Re: Calling for a safer, more people-oriented vision for 51st Street between Cameron Road and Berkman Drive

We are a coalition of neighborhood associations, advocacy organizations, local businesses, and residents writing to support a safe, vibrant, and economically productive vision for 51st Street between Cameron Road and Berkman Drive.

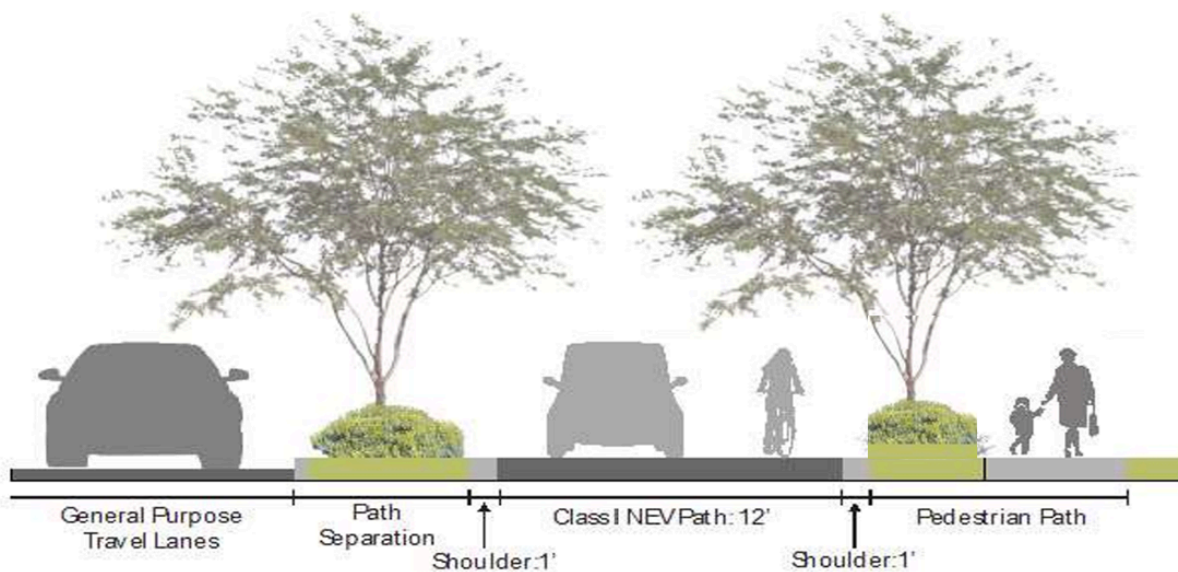
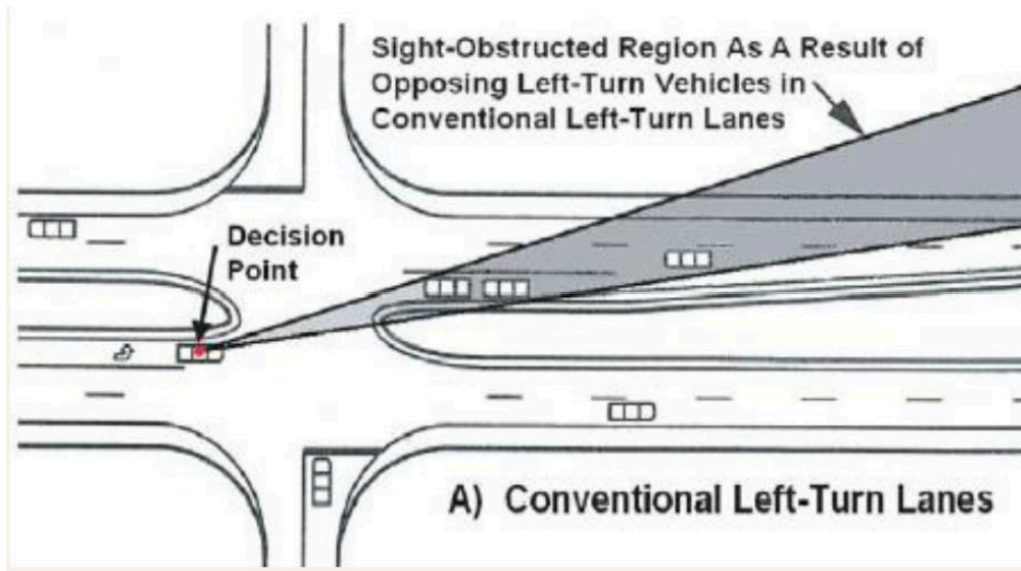
- AADT: 28,687 (2018)
- Roundabouts
- Highway Safety Manual says four lane roads are bad (see CMF Clearinghouse website (screenshot below of results for "lane conversion") [CMF Clearinghouse](#))

- Left turn lanes block view of oncoming traffic ([good image of why this is problematic](#) [pasted below](#))
- Design should incorporate 50:50 modeshare (space for golf carts, low speed vehicles, e-trikes). The Austin Strategic Mobility Plan on page 136 states to integrate low speed electric vehicles. I've pasted below a cross section from [this multimodal plan](#) in Coachella Valley
